Access Compliance Report Public Rights-of-Way (Curb Ramps)

Main Street: KENSINGTON_RD		Cross Street: SALMON_DR		Location:	NE
ADA ID: RPRK211216113316	Ramp Type:Type 1 - Perpendicular Diagonal Initial Pass/Fail: Pass		Overall Compliance: No	Severity Score:	10
Codes/Mitigation Info/Possible Solution			Field Measurements/Component Compliance

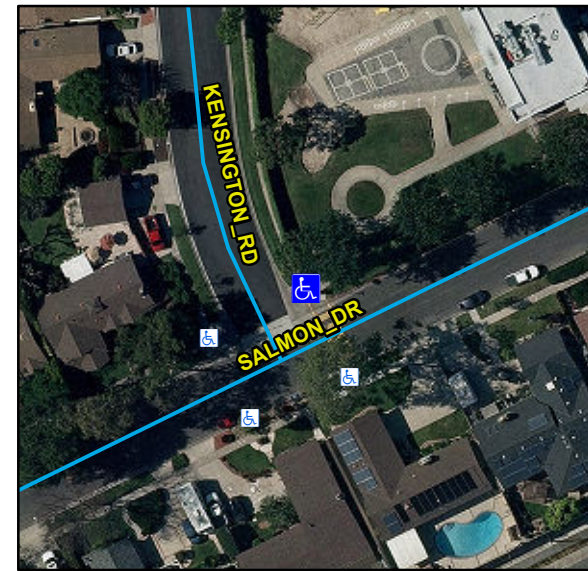
Remove & Replace Curb Ramp With Two New Directional Ramps or Equivalent. Utility Present.
